REQUEST FOR INFORMATION NOT ADDRESSED IN THIS CCO REMAIN IN FORCE							
	03/08/10	MEP INTEGRATION			SYC	FW	110
MARK	DATE	DESCRIPTIONS			BY	CH'D	CCO#
REVISIONS

CONTRACT CHANGE ORDER NO. \_\_\_\_\_  
SHEET \_\_\_\_\_ OF \_\_\_\_\_

DETAILS  
BRIDGE STRUCTURES GIRDER WESTBOUND  
SKYWAY STRUCTURES-HINGE BW  
SCALE AS NOTED

PLAN - HINGE BW  
SCALE: 1:75

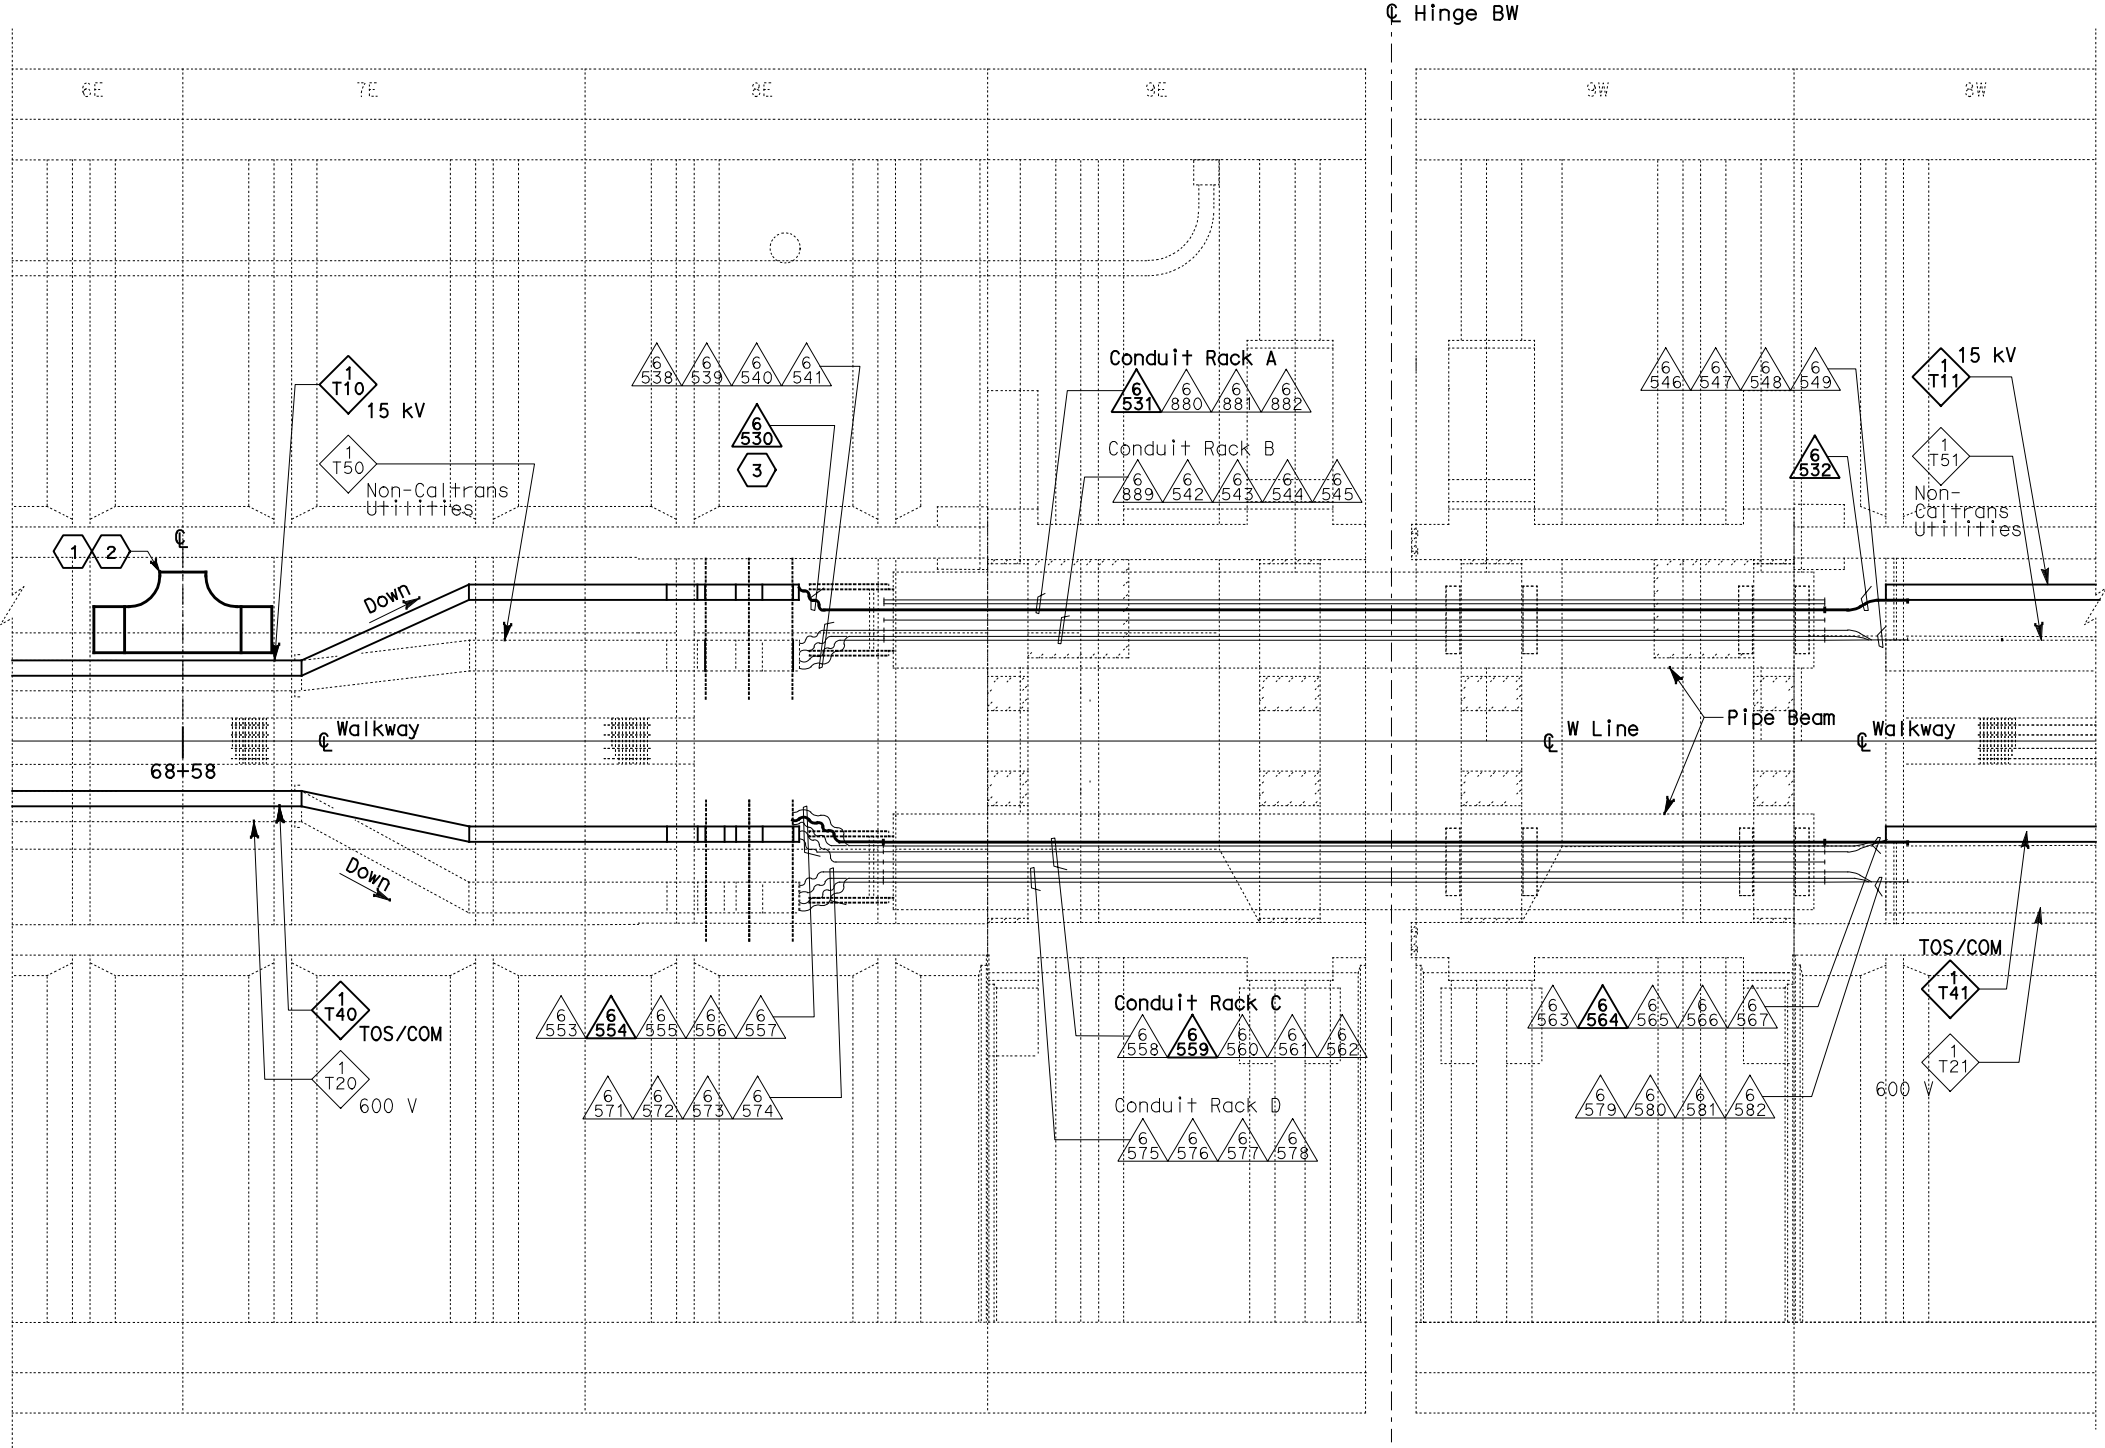
- SHEET NOTES:
- Furnish and install splice cable tray as shown on sheet E-663, plan detail 1.
  - Mount splice cable tray between diaphragms at Station 68+58 as shown on sheet E-605 and secure properly. See sheet E-663, section detail 4.
  - In order to be able to pull the 15kV cable, the Contractor shall disassemble the 15kV flexible conduit installation. The 15kV flexible conduit shall be reinstalled after the 15kV cable has been installed.
